DATE: September 12, 2025
REF: SUP25-0026

FROM: Toledo City Plan Commission, Lisa Cottrell, Secretary

SUBJECT: Special Use Permit for Used Auto Sales at 3952 Jackman Road

SITE PLAN

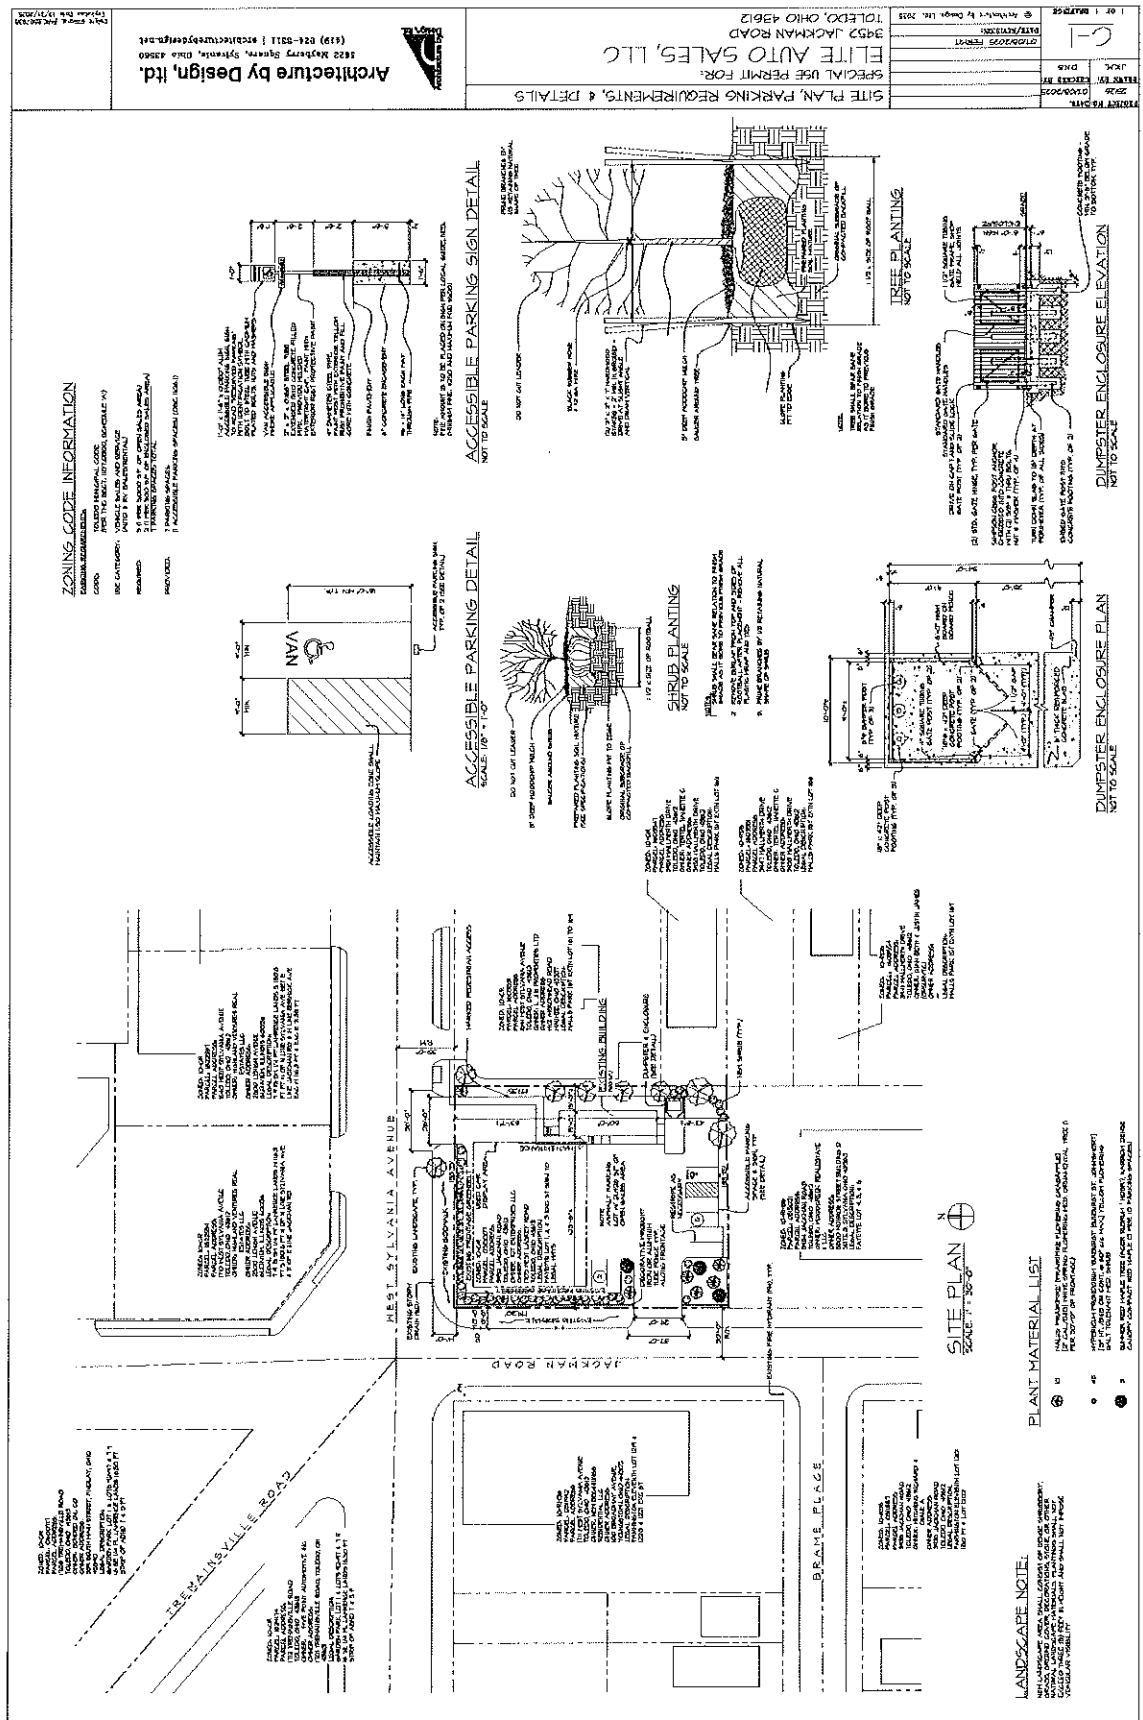
Site design standards require that the site plan delineate parking areas and drive aisles for the outdoor display area and customer/employee parking per TMC§1104.0306. While customer/employee parking is depicted on the site plan, the individual spaces and drive aisles for the outdoor display area are not. The outdoor display area is only designated by an outlined area located in the northwest portion of the site. If elevated displays, lifts or metal structures are used for vehicle display, the location of such displays shall also be depicted on the site plan and are not permitted in any required front yard per TMC§1104.0302. Additionally, curbs shall be incorporated to prevent encroachment of vehicles into required setbacks and landscape areas, a fifty foot (50') separation is required between any open display sales lot and a Residential district, and fencing for customer display areas shall meet the requirements of TMC§1105.0302 and TMC§1108.0203(H) for outdoor storage screening requirements. A decorative wrought iron or aluminum tube fence is proposed for the noted display area along Jackman Road and Sylvania Avenue. The fence shall meet the requirements of TMC§1105.0302. A revised site plan shall be submitted that delineates the display spaces and drive aisles, elevated displays if any, and all other noted requirements as applicable. These are listed as conditions of approval.

TMC§1107.1202(B) outlines where off-street parking facilities, including vehicular drives and maneuvering areas, are prohibited in Commercial Districts. In this case, they are prohibited within any required landscape buffer. The parking spaces that face the southern property line are five feet (5') to less than five feet (5') from the property line. A ten-foot (10') landscape buffer is required for the southern property line; therefore, the proposal does not meet this requirement. In addition, parking is prohibited within fifteen feet (15') of the street right-of-way along Sylvania Avenue and within twenty-five feet (25') of the street right-of-way along Jackman Road per TMC§1107.1202(B)(3). The site plan depicts an existing frontage greenbelt that encompasses the grass area between the public sidewalk and paved lot. This area appears to be ten feet (10') or less in width and therefore does not meet this requirement. The site plan shall be revised so that no parking, including vehicular drives, maneuvering areas and vehicle display areas are located within fifteen feet (15') of the Sylvania Avenue right-of-way and within twenty-five feet (25') of the Jackman Road right-of-way. Compliance with TMC§1107.1202(B) is listed as a condition of approval.

Wheel stops are required per TMC§1107.1907 whenever a parking lot extends to a property line, sidewalk, planting strip, or building. Wheel stops are required for the five (5) customer/employee parking spots along the southern property line. All other parking spaces shall incorporate curbs or other substantial permanent barriers to prevent encroachment of vehicles into the required setback and landscape areas per the use standards for Auto and RV Sales in TMC§1104.0302. These are listed as conditions of approval.

13. No other primary use shall be permitted on the subject property.
14. All used motor vehicles parked or displayed outdoors shall conform to Chapter 337, Safety and Equipment, of the Traffic code and shall be operable.
15. Per TMC§1104.0308, all vehicles on display must be parked in striped parking spaces that shall be designated on the approved site plan. Vehicle parking that deviates from the approved site plan shall not be permitted. **Not acceptable as depicted. A revised site plan shall be submitted that delineates the outdoor display area.**

17. Per TMC§1104.0302(B), display areas shall incorporate curbs and other substantial permanent barriers to prevent encroachment of vehicles into the required setback and landscaped areas. **Not acceptable as depicted. A revised site plan shall be submitted that depicts the required curb or barrier.**

21. Per TMC§1107.1202(B), off-street parking facilities, including vehicular drives and maneuvering areas, are prohibited on the subject site within the ten feet (10') landscape buffer along the southern property line, within fifteen feet (15') of Sylvania Avenue right-of-way, and within twenty-five feet (25') of the Jackman Road right-of-way. **Not acceptable as depicted. The site plan shall be revised so that no parking facilities, including vehicular drives, maneuvering areas and outdoor vehicle display areas are located where noted.**

24. Wheel stops shall be provided whenever a parking lot extends to a property line, sidewalk, planting strip, or building per TMC§1107.1907. Based on the submitted site plan, wheel stops are required for the five (5) customer/employee parking space along the southern property line. **Not acceptable as depicted. Approved wheel stops shall be provided and depicted on a revised site plan for parking spaces as required.**

- a. A fifteen-foot (15') frontage greenbelt is required along Sylvania Avenue with five (5) trees and a solid evergreen hedge per TMC§1108.0202. In addition, a twenty-five-foot (25') frontage greenbelt is required along Jackman Road with six (6) trees and a solid evergreen hedge. **Not acceptable as depicted. A revised landscape plan shall be submitted that depicts the required frontage greenbelt width and required trees.** The species and/or cultivar of the trees to be planted in the frontage greenbelt shall not be "messy" in nature so that fruit, seeds, etc. do not drop on the adjacent public sidewalk, and the proposed shrubs shall be evergreen.

- b. A Type "A" landscape buffer is required along the southern property line where the abutting property is zoned RM36 per TMC§1108.0203. A ten-foot (10') wide buffer with six (6) trees, twenty (20) shrubs and a privacy fence is required. One (1) new tree, one (1) existing tree and three (3) shrubs are depicted on the site plan. The abutting property to the south has a privacy fence for a portion of the property line. **Not acceptable as depicted. A revised landscape plan shall be submitted that depicts the required six (6) trees and twenty (20) shrubs and a privacy fence, where not currently provided.**

- d. Dumpster screening is required per TMC§1108.0203(G). **Acceptable as depicted.**
 - e. Parking lot perimeter landscaping is required per TMC§1108.0204(B)(9) and must be installed along any parking lot area adjacent to a street, place, or driveway, or is visible from an immediately adjacent property. **Not acceptable as depicted. Parking lot perimeter landscaping shall meet this requirement by complying with Condition 19a and 19b.**

- f. Interior landscaping for parking lots is required per TMC§1108.0204 at a rate of twenty (20) square feet per parking space. In addition, two (2) canopy trees and six (6) shrubs for each ten (10) parking spaces are required. The outdoor vehicle display area needs to be depicted on the site plan to determine the required interior parking lot landscaping. **Not acceptable as depicted. A revised landscape plan shall be submitted that depicts the required interior landscaping per TMC§1108.0204 based on a revised site plan that delineates the outdoor vehicle display area.**

- g. Interior site landscaping is required per TMC§1108.0205. One (1) 2-inch caliper tree, landscaping at major building entrances, and foundation plantings are required. One (1) tree is depicted on the site plan. **Not acceptable as depicted. A revised landscape plan shall be submitted that depicts the required foundations plantings and landscaping at major building entrances.**

- j. The location, number, height, diameter and species of any materials to be planted and maintained, as well as the location and number of any existing trees to be retained. **Not acceptable as depicted. The species and size of trees to be preserved shall be provided.**

- m. The location, height and materials for any fencing to be installed and maintained. **Not acceptable as depicted. A revised site plan shall be submitted depicting the location of all required fencing and fence details. This shall include a note that a new privacy fence shall be installed along the southern property line should the existing privacy fence ever be removed from the abutting property.**

- n. The location and direction of any proposed lighting. All site lighting shall be fully directed downward, recessed, or adequately shielded to direct light away from adjacent properties, rights of way, or the sky above the fixtures per TMC§1107.1908. The existing site lighting is not depicted on the site plan. **Not acceptable as depicted. A revised site plan shall be submitted depicting the site lighting if it will continue to be used. All missing fixtures shall be replaced. If the lighting is not operable and/or is not intended to be used or fixtures not replaced, the lighting shall be removed from the site.**
